Customer schematic & The waveform which failed in the stop condition

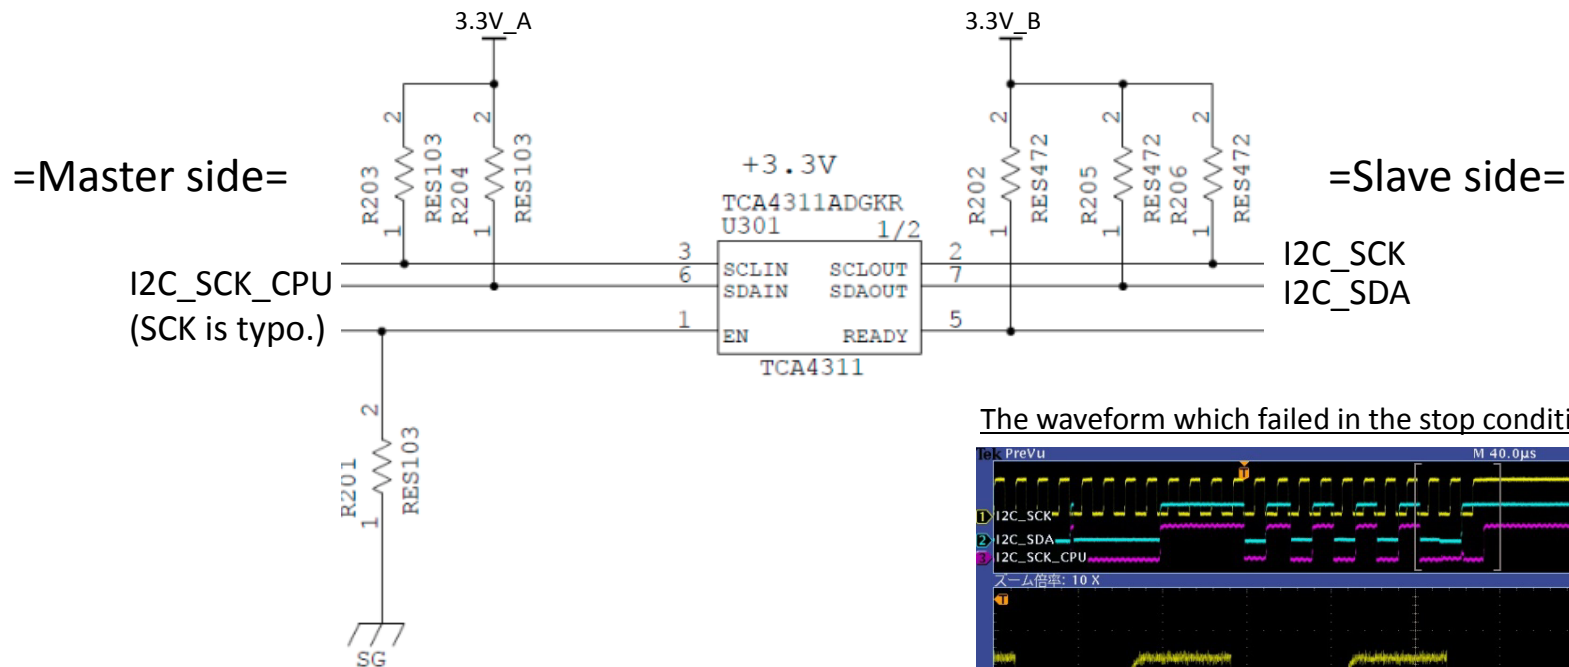
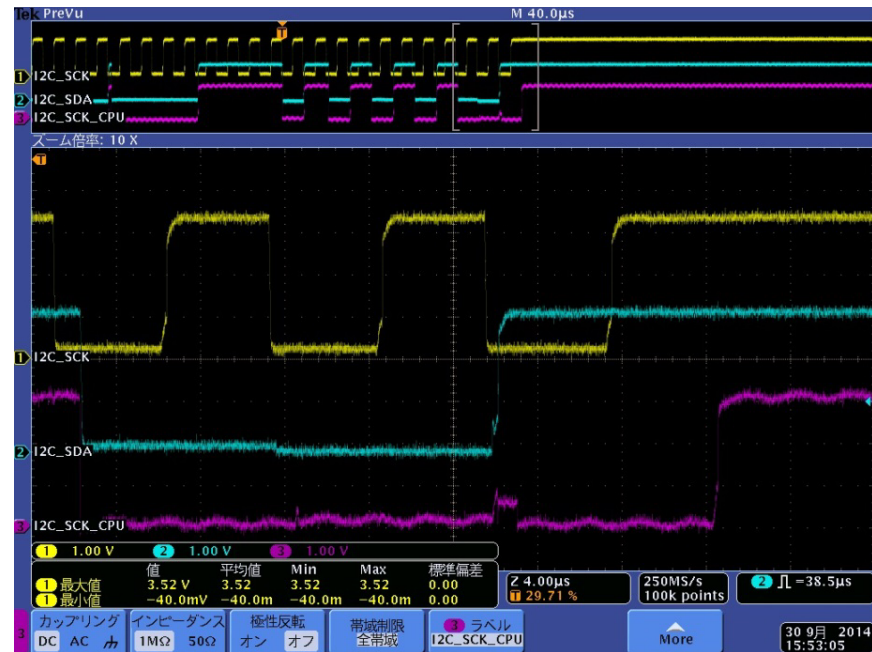
[Q1]

- Why did it fail in the stop condition in the slave side?
- Please tell me what they should do to operate it normally.

[Q2]

It worked normally when they changed R203&R204 to 4.7kΩ.
 Why does it seem to be?
 Can you explain the reason?
